Memorandum

To: Anne Hersch, City of Albany
From: Jonathan L. Kramer 
Date: January 14, 2013
RE: PA12-050 (AT&T Mobility)
1035 San Pablo Avenue, Albany, California

Figure 1: Existing AT&T signal coverage in the Cellular band without the proposed site operational, all as asserted by AT&T as of May 2012. (Source: AT&T Mobility).

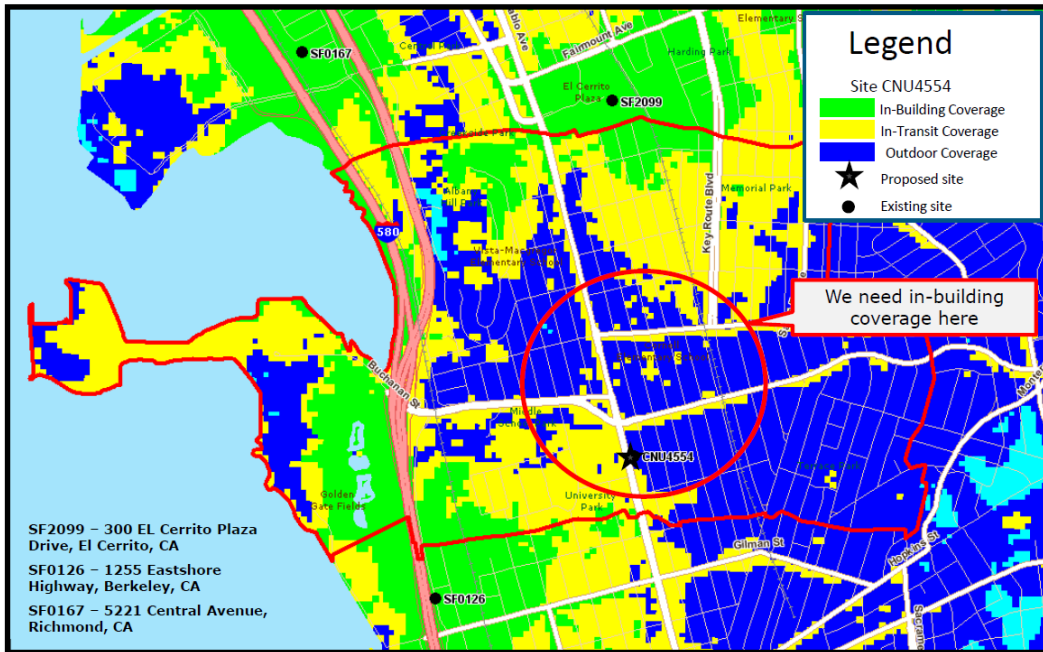
Figure 1 below depicts AT&T's computer projection assertions of the existing coverage levels in only the Cellular band for the area surrounding the proposed site as that coverage appears to have existed in mid-2012. The coverage map indicates that AT&T had "outdoor" signal level coverage—as AT&T defines that term subjectively—to about seventy percent (70%) the area of AT&T interest surrounding the proposed site.

Comparing Figure 2 to Figure 1, the maps stand for the proposition that AT&T is attempting to improve its service in the Cellular band in the central and southern portions of Albany. The maps suggest subjectively that AT&T has a lower grade of existing coverage in its Cellular band of service in the areas mentioned. Ultimately, AT&T's proposed project will not satisfy its own criteria to achieve "in-building coverage" within the circled area of Figure 1, above, but it will come very close to meeting that goal.

Figure 4: Site as proposed by AT&T (Photo Source: AT&T)

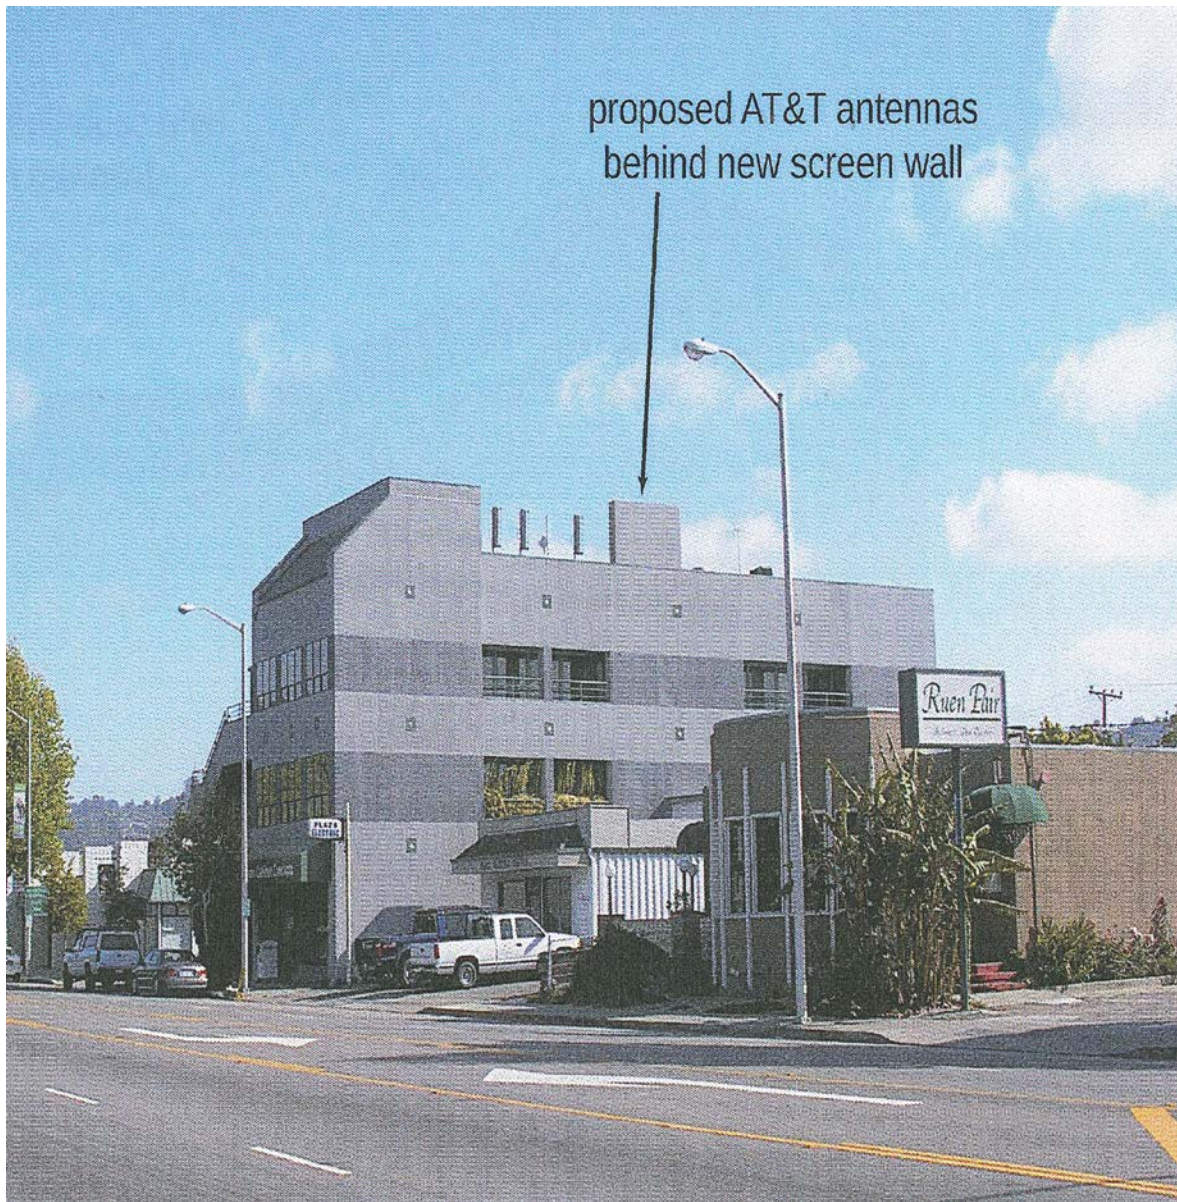
In Figure 4, below, AT&T presents its photo simulation illustrating how the shown portion of the site will look with its proposed screening for AT&T’s antennas.

It is my understanding that the Albany Planning Code does not permit the rooftop massing that would occur were the existing Sprint Nextel antennas to also be screened, so at least the current design proposal results in the screening of AT&T's project.
